Name: Morné de Jager
Cell: 082 565 4059
E-mail: morne@menco.co.za
Date: 24 June 2021
Ref: Komsberg West WEF

SPECIALIST OPINION: PROPOSED KOMSBERG WEST WIND ENERGY FACILITY PART II AMENDMENT

Figure 1: Locations of wind turbines as considered in this letter of opinion

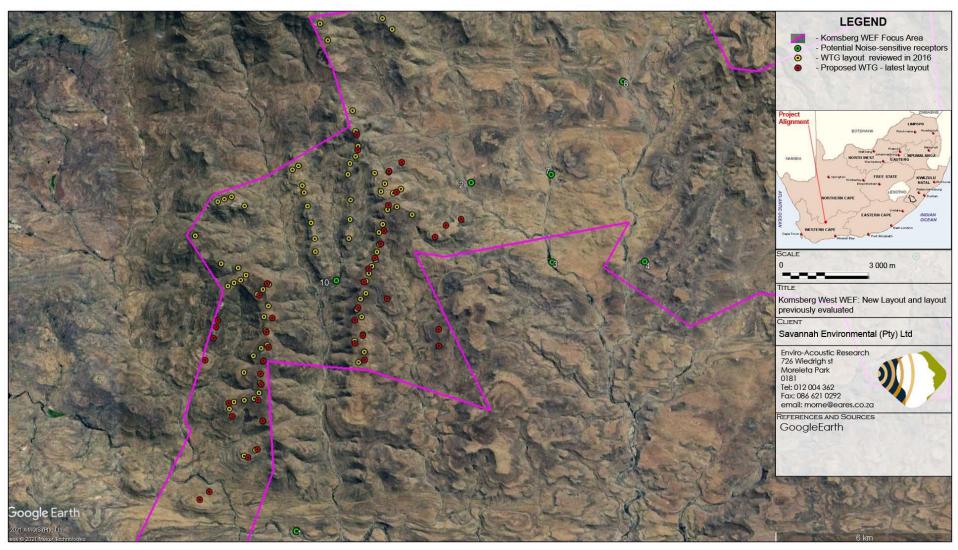
The developer of the Komsberg East Wind Farm has since optimized the layout (See also **Figure 1** for the new layout) of the wind farm, locating the wind turbines at optimal locations and changing the WTG specifications.

The updated layout reduces the total number of WTGs located within 1,500 m, which would reduce the noise level at this receptor. Therefore, considering the location of the WTGs and the potential noise impact, it is my opinion that:

- in terms of statement 1 (section 7.3.2 of the Addendum Report, AC-KWF/A-ENIA/201603-Rev 0), the proposed changes do not introduce new wind turbines closer than 1,000 m from an identified NSD.
- the change will not increase the significance of the noise impact at NSD10, subject that a wind turbine with a maximum sound power emission level of 108.4 dBA are used by the developer;
- a full noise impact assessment with new modeling will not be required and the recommendations as contained in the previous document will still be valid;
- the cumulative noise impact will not change, as there are no new or proposed wind turbines (from a different WEF), located within 2,000m from identified NSD to cumulatively increase the noise levels;
- there are no new limitations or assumptions.

If the developer selects a wind turbine generator with a sound power emission level exceeding 108.4 dBA, the noise impact assessment must be reviewed in detail. Should you require any further details, or have any additional questions, please do not hesitate to call me on the above numbers.
